**THE CITY OF ALEXANDER CITY, ALABAMA  
MULTI AGENCY WASTEWATER SOLUTION – PROJECT “A”  
HIGHWAY 63 SEWER FORCE MAIN  
BID #22-16  
(SRF PROJECT CS010329-05)**

**ADDENDUM NO. 1**

**STORM DETAIL - AL ST #63 STA 269+50**

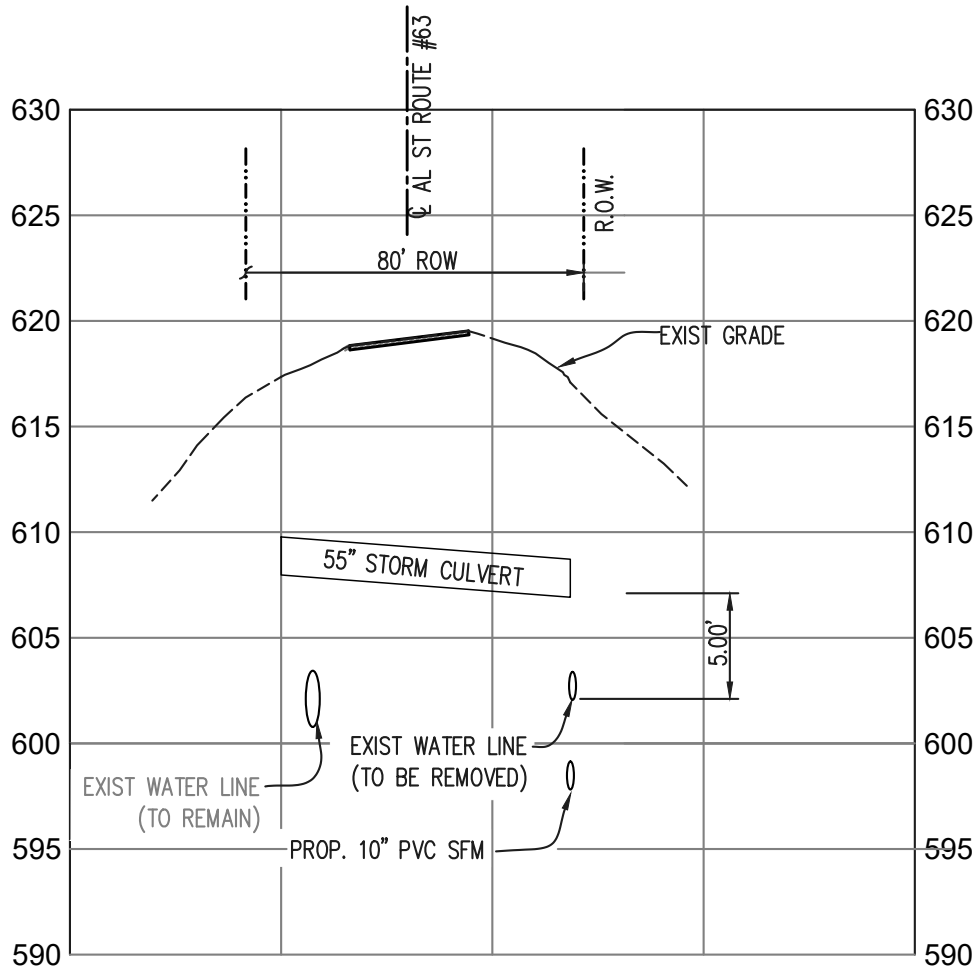
Sheet 22 Storm Detail – AL ST #63 STA 269+50' see attached profile.
